# DC/20/4597/FUL

Proposed two storey & single storey extensions and alterations. Repositioning of cartlodge (previously approved) and new vehicular access.

148 Bucklesham Road, Purdis Farm, IP3 8TZ

Comments by Mr and Mrs R Prime – 27 April 2001

Appendix 1 – Our West aspect from breakfast room (current and proposed)

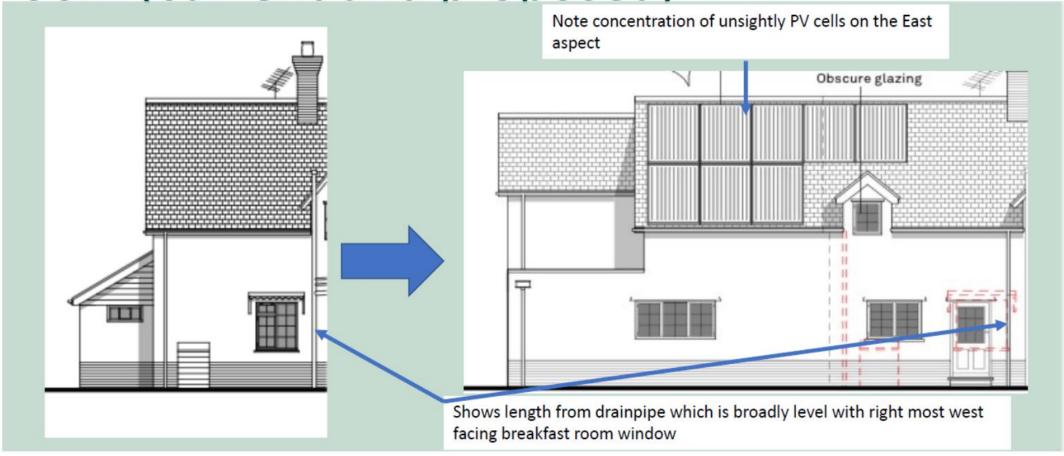
- Scope and significant scale of revised extension (see Appendices for visual support)
  - c.75-80% increase in length of east elevation (facing us) of subject property;

- Importantly, from our breakfast room windows length increase is c.100% increase at two storey level and c.180% at single storey see Appendix 1 in particular;

- Permitted Development 4.3m vs 3m it is a 43% increase and material see Appendix 1 and 2. 3 metres PD at the south east corner would still leave a c.7 metre room length at first floor level. Note PD would not allow access changes/cartlodge;

# Appendix 3 – 45 degree rule

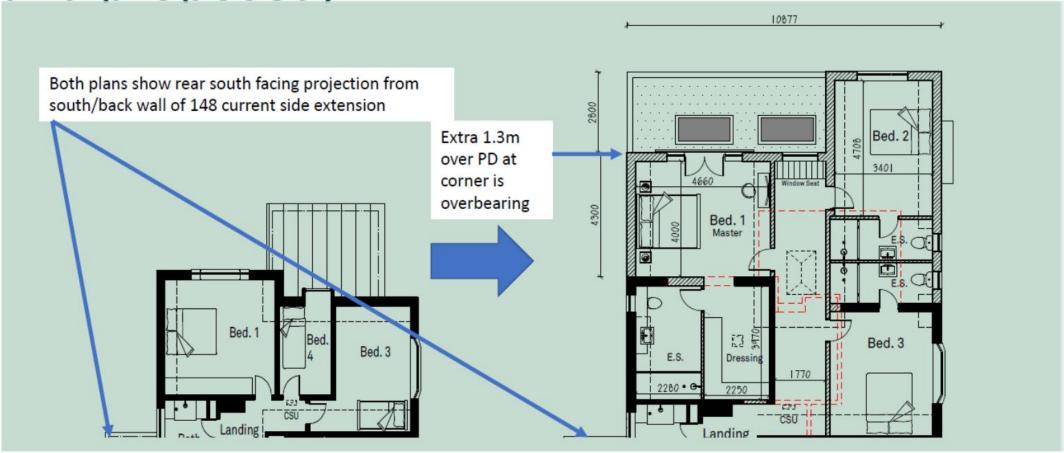
- Planning officer comments in section 6.4 "just meets the 45 degree light test" —applicant's drawings actually show only French doors have an unblighted view there are no bifold doors in our kitchen/breakfast room as drawn all 7 windows blighted see Appendix 3 and 4;

# Appendix 4 – 45 degree rule (continued)

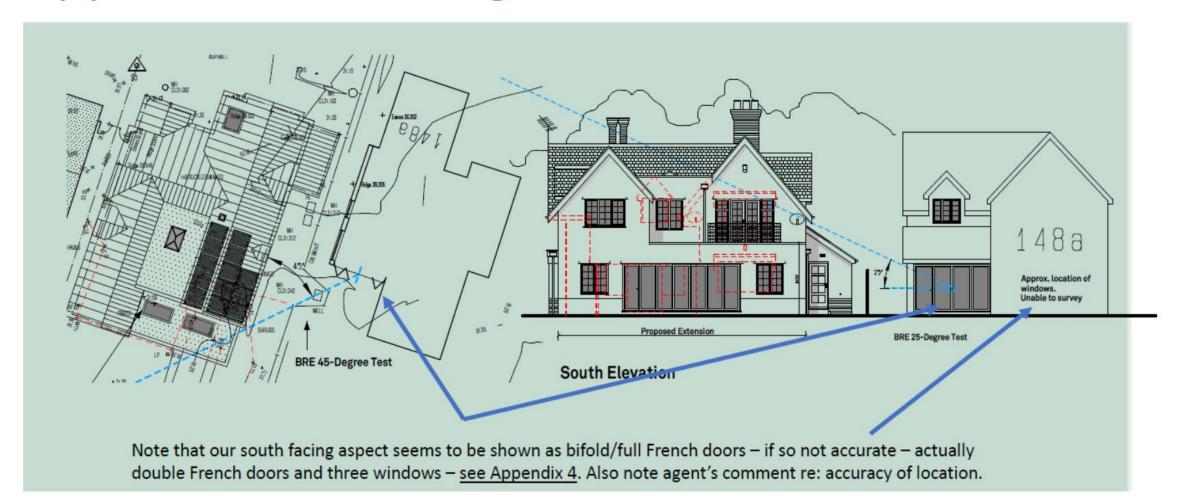
Double aspect breakfast room windows total 3 south facing and 4 west facing – note that as the 45 degree rule in Appendix 3 is drawn all 3 south facing and 4 west facing windows are blighted

Seating area in breakfast room and all windows would therefore be fully obsured as drawn by applicant

Approximate mid point showing all windows blighted as French doors form entry/egress only
